SERVICE BULLETIN #135

05/31/2016

9562 Spoke Wheel

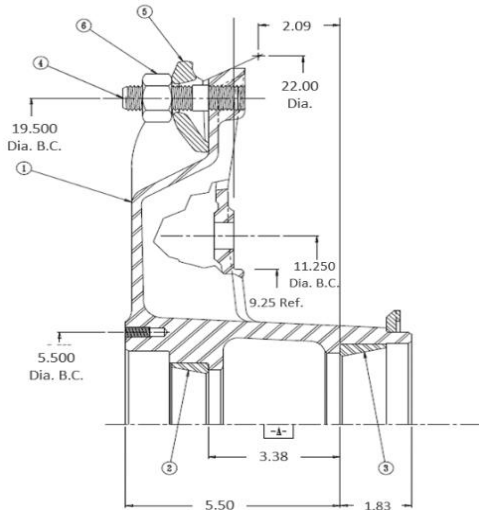
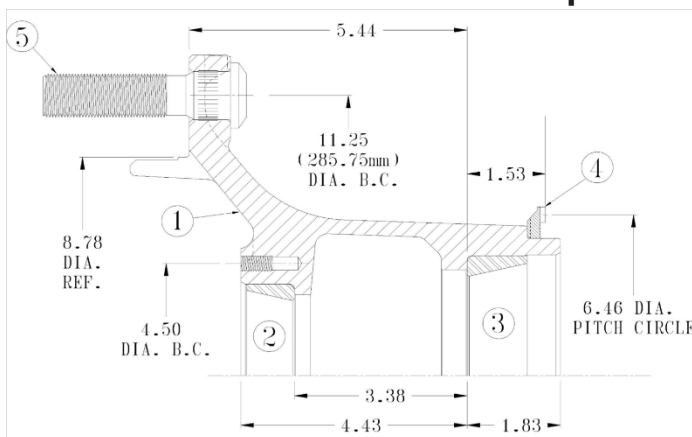
Upon depletion of inventory, the 9562 spoke will become obsolete with no direct replacement. We do however recommend a replacement: the 10-stud 2520 hub. This requires changing brake drums, changing to a disc hub, and changing to disc wheels instead of demountable rims. If you have any questions, please contact the Webb Engineering department via email to engineering@webbwheel.com or call 256-736-6356.

Replacement Option

2520 Bill of Material			
Item	Part No.	Description	Qty
1	2520T	10 Stud 11.25" Outboard Steer Hub	1
2	3720	Outer Bearing Cup	1
3	HM212011	Inner Bearing Cup	1
4	51053	ABS Ring	1
5	Varies	Serrated Stud (M22x1.5 or 3/4-16)	10
